**REVISED**

REF: SUP-5006-24

| Request               | - | Special Use Permit for a gas station   |
| Location              | - | 1950 S. Reynolds Road  |

DRAWING NO.:		DATE:		JUNE 2024		DRAWN BY:	
C200		DWG SCALE:		1"=20'		CHECKED BY:	
		PROJECT NO.:					
		APPROVED BY:					
SHEET 1 OF 4

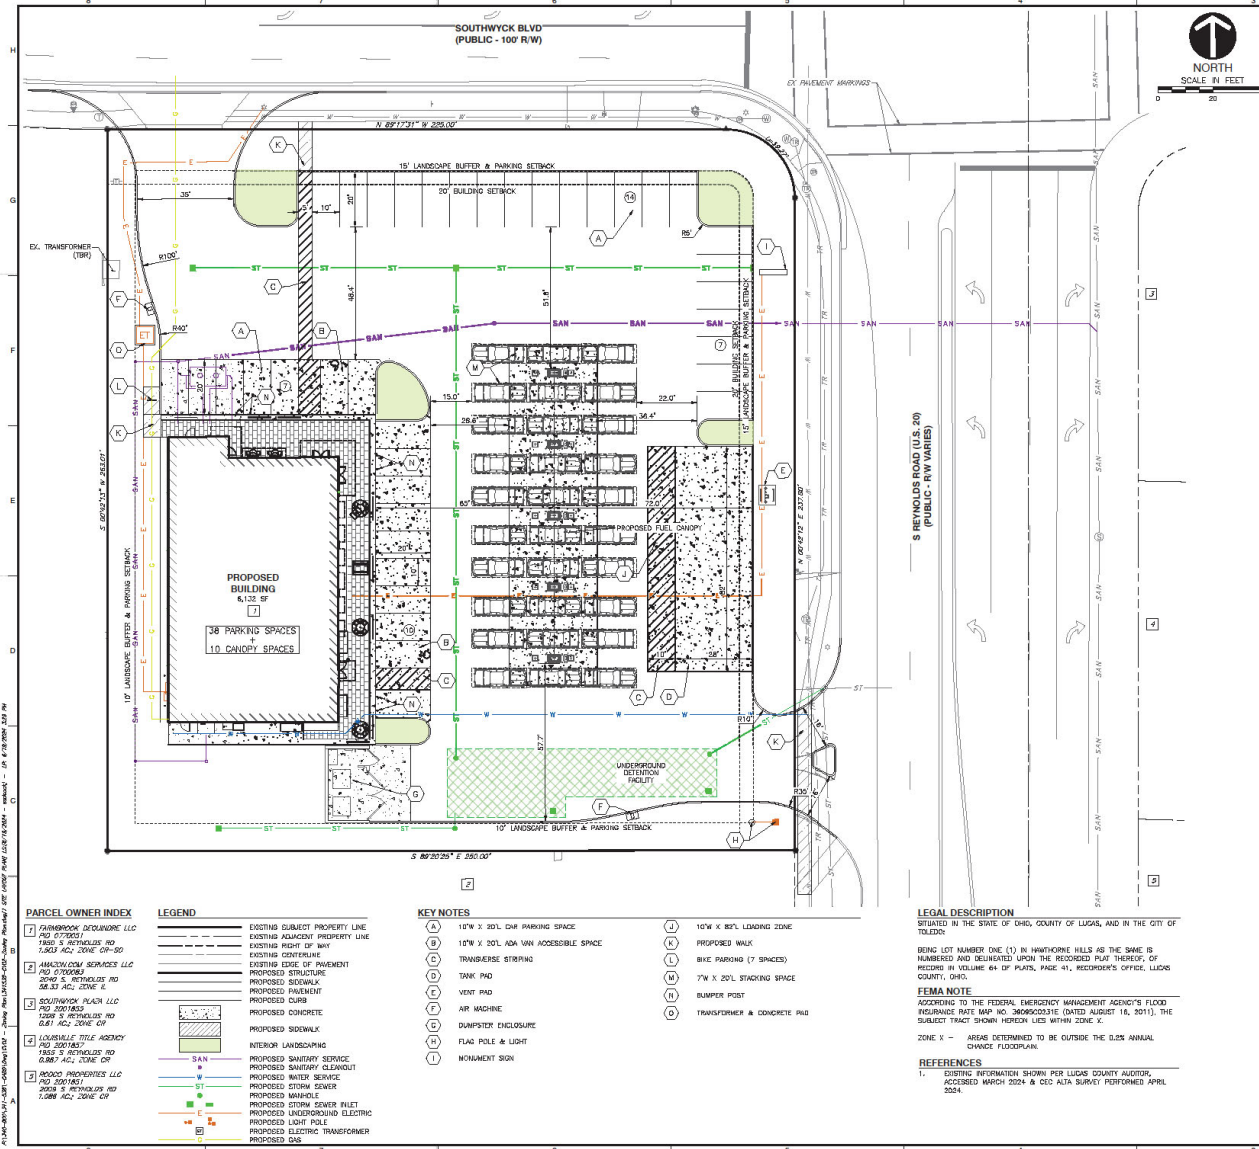
The submitted site plan and elevation drawings meet the above design and dimensional standards. Two air stations are noted on the site plan. However, to be compliant with this section, they must be free of charge to customers which is listed as a condition of approval. Staff is not recommending the hours of operation be limited since the surrounding land uses and zoning are commercial or industrial in nature.

30. Accessible parking signage is required to be shown and must comply with TMC§ 1107.1704.
31. Gas pumps must be moved 3' to the east to allow room for a two-way drive aisle with the gas pump stacking per TMC§1107.1911.
32. Islands at the corners of the building sidewalk must be reduced to no more than 18' off of sidewalk.

40. Sidewalks shall be provided along all public streets in commercial districts per TMC§1107.1303. **Acceptable as depicted.**
41. Clear pedestrian pathways shall be provided on the site. The site plan depicts tables along the east side of the building that obstruct pedestrian circulation and does not provide a clear pedestrian path. **Not acceptable as depicted on site plan submitted. The area shall be redesigned to provide a clear pedestrian path and shown on a revised site plan.**

42. Wheel stops shall be provided whenever a parking lot extends to a property line, sidewalk, planting strip, or building per TMC§1107.1907. Wheel stops are required for the 38 proposed marked parking spaces. Wheel stops are not provided that meet this requirement. **Not acceptable as depicted on the site plan submitted. Approved wheel stops shall be provided and depicted on a revised site plan.**

# LANDSCAPE PLAN

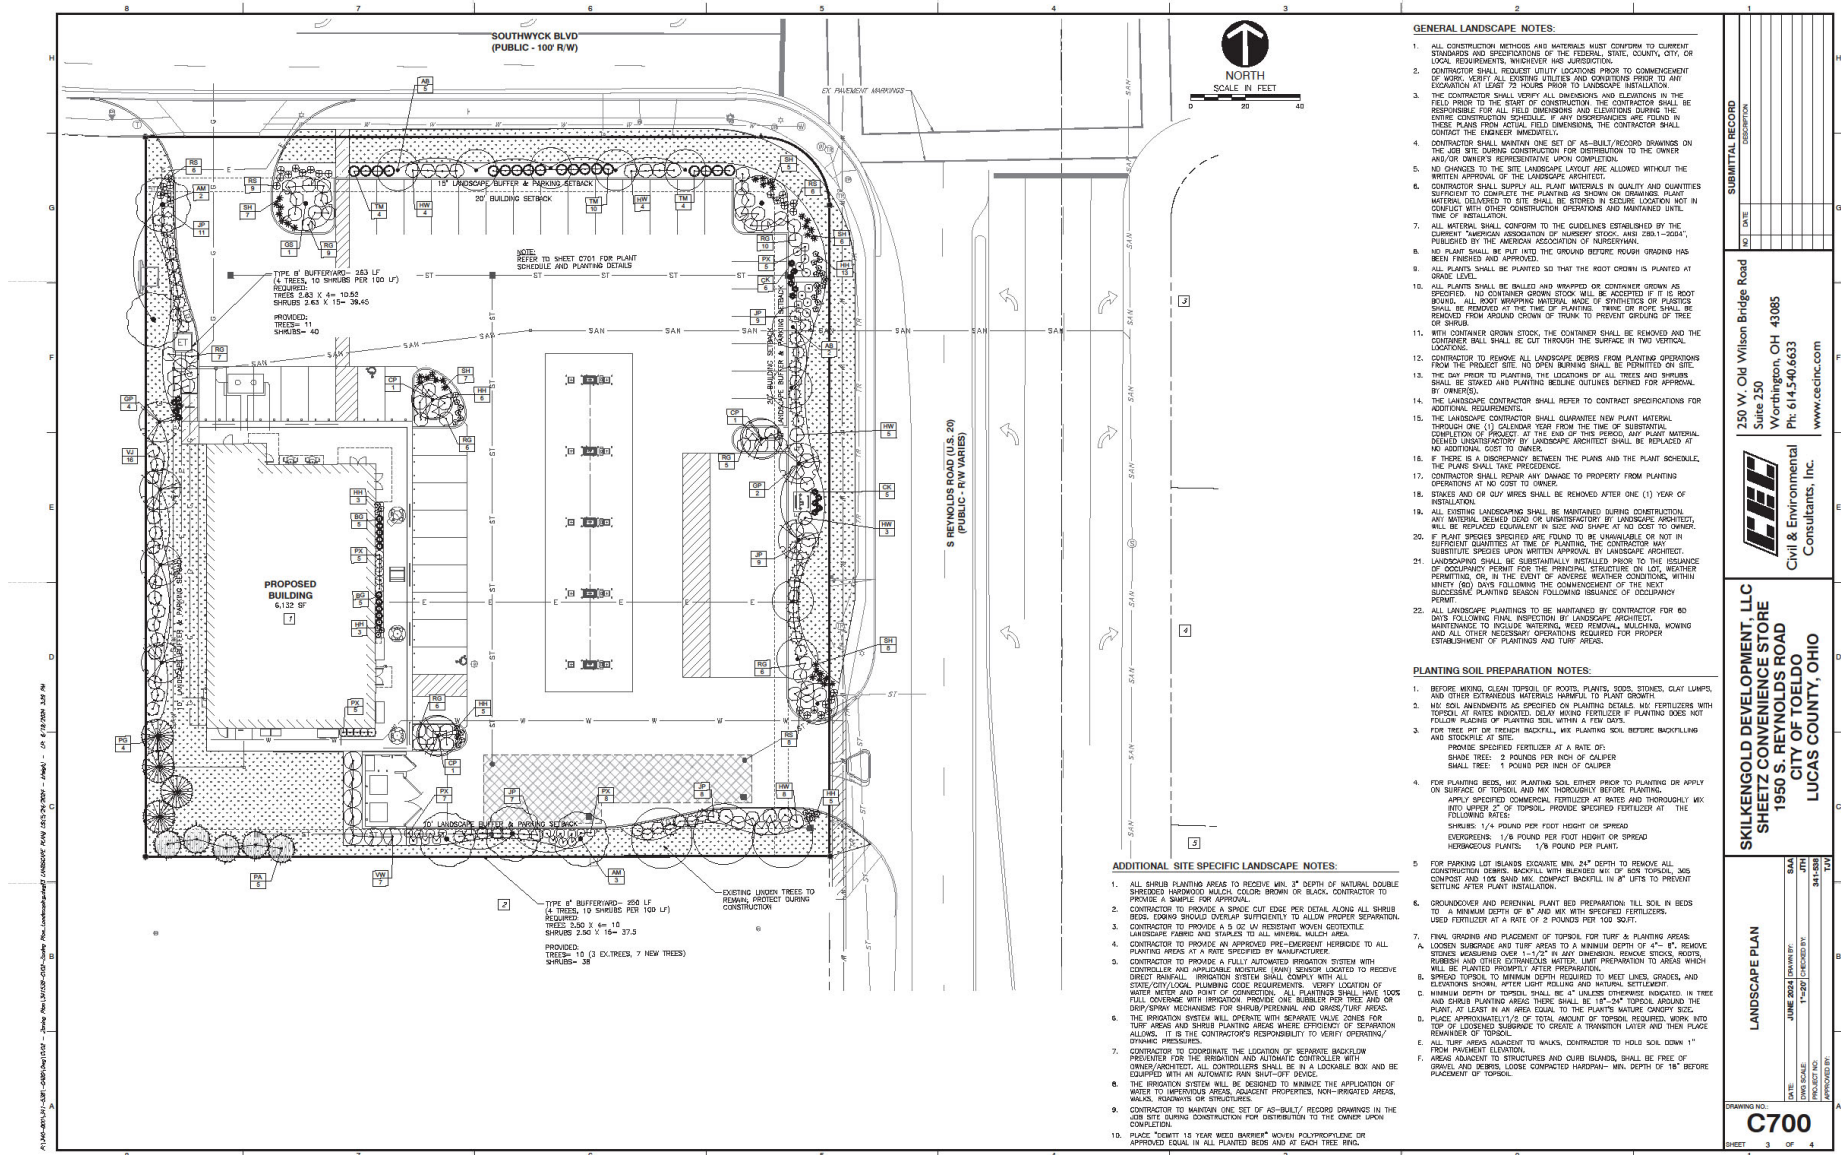
- a. A 15 foot frontage greenbelt along Southwyck Boulevard and Reynolds Road per TMC§1108.0202. The greenbelt shall consist of eight (8) trees on both of the streets. The site plan depicts five (5) trees along Southwyck and eight (8) trees along Reynolds. **Not acceptable as depicted on landscaping plan submitted. Three (3) additional trees shall be provided along Southwyck and depicted on a revised landscaping plan.**

- c. Dumpster screening per TMC§1108.0203. **Acceptable as depicted.**
  - d. Perimeter parking lot landscaping along parking areas adjacent to a street per TMC§1108.0204(B.9). A continuous evergreen shrub row shall per provided. **Not acceptable as depicted on landscaping plan submitted. All shrubs shall be evergreen and noted on a revised landscaping plan.**

- e. Interior parking lot landscaping per TMC§1108.0204. Eight (8) canopy trees and 23 shrubs are to be provided. Four (4) trees and 25 shrubs are depicted on the landscape plan. **Not acceptable as depicted on landscaping plan submitted. Four (4) additional canopy trees shall be provided and shown on a revised landscaping plan.**

- f. Interior site landscaping per TMC§1108.0205. Seven (7) trees, landscaping at major building entrances, and landscaping along all building sides is required. **Not acceptable as depicted on landscaping plan submitted. The seven (7) required trees and foundation plantings along the west building façade and where they fit along the south building façade shall be provided and shown on a revised landscaping plan.**

BUILDING ELEVATIONS - WEST & SOUTH

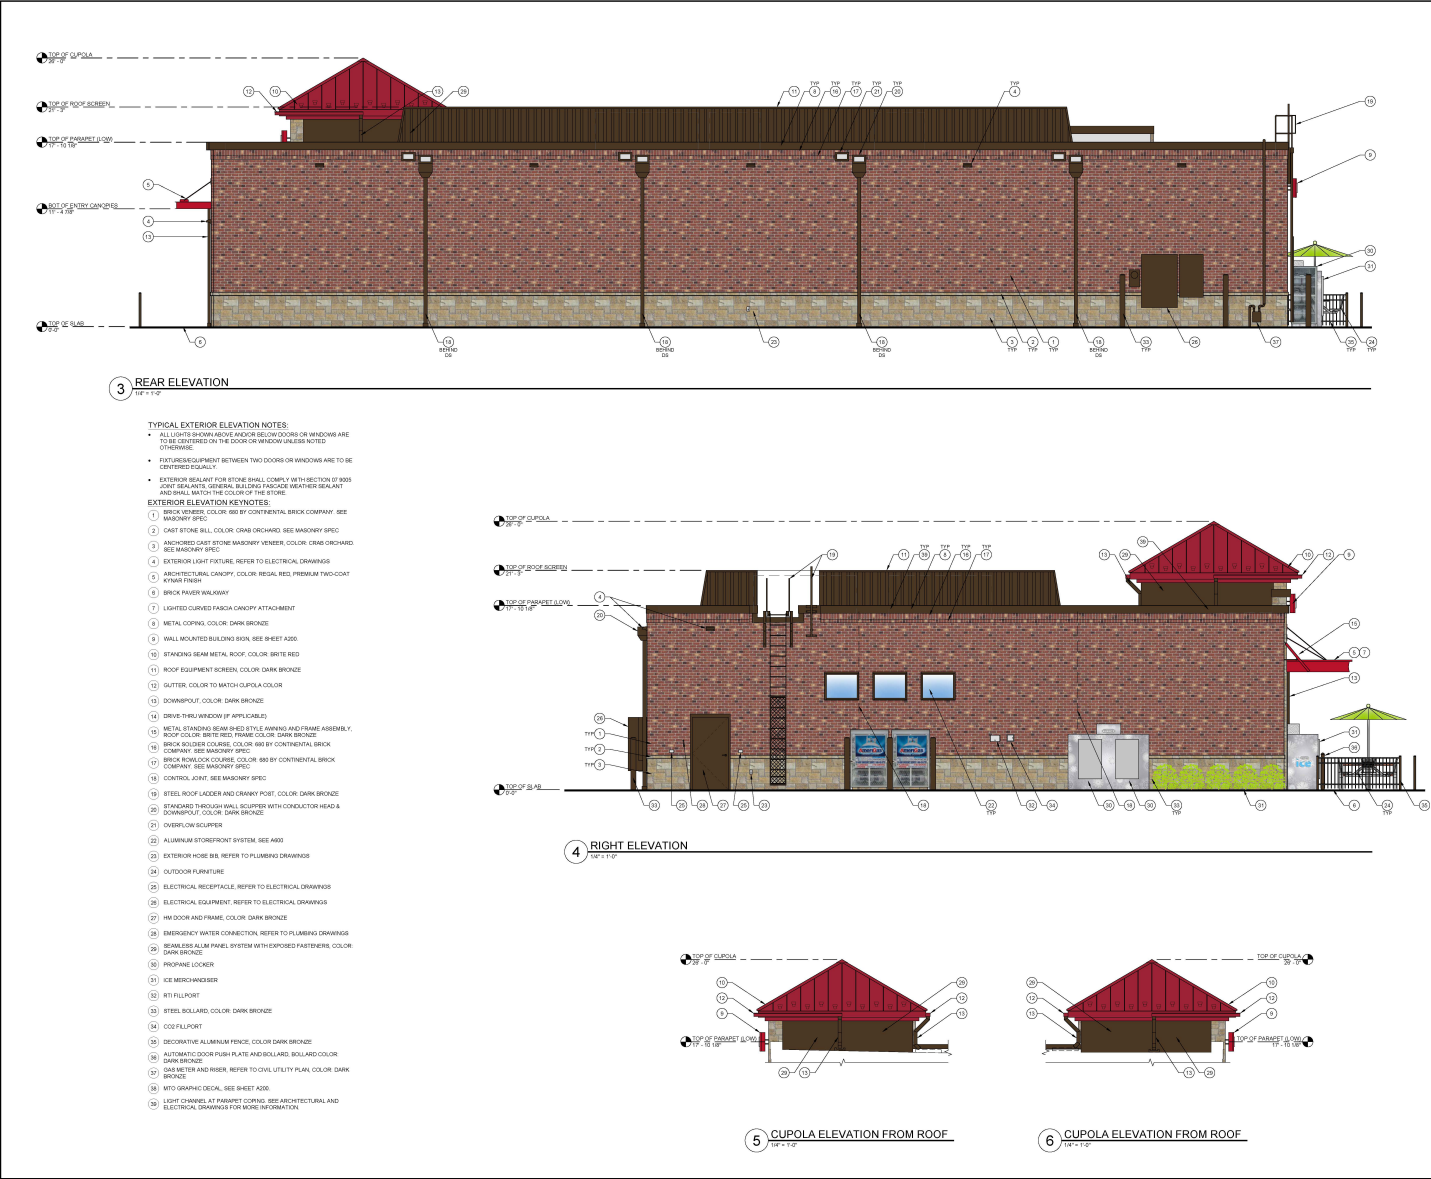
- **Building Character and Overall Design** - Per TMC§1109.0205, the building is required to be responsive to its context and contribute to the established character of the area. Building design is not meant to be based on a standardized formula associated with a business or franchise. In addition, it is required to provide a sense of human scale through the use of variations in massing, wall articulations and varying building materials. While such things as different buildings materials, windows, awnings, and defined building entrances are incorporated into the north and east building elevations, additions such as greater articulation or material change in the proposed columns and a more pronounced area at the top of the building would assist to further “breaking-up” long wall façades. The south and west elevations provide little to no relief from the proposed single wall massing. These elevations need to be redesigned to be consistent with the north and east elevations and to achieve the intent of this section. A revised building elevation shall be submitted depicting minimal wall articulation and variation in massing on the south and west facing elevations and is listed as a condition of approval.

47. All building elevations shall meet the building design standards in TMC1109.0205. **Not acceptable as depicted on the building elevations submitted. Revised building elevation shall be submitted to the Plan Director for review and approval.** Revisions to include:

- a. A well-defined building top for all elevations by using features such as distinct and multiple architectural roof forms, clearly pronounced eaves, and/or distinct parapet designs and cornice treatments.

- b. Increased articulation or change in material of the proposed columns on the east elevation.
  - c. The south and west building elevations shall be redesigned to be consistent with the north and east elevations and to create a sense of human scale, not a single wall mass.
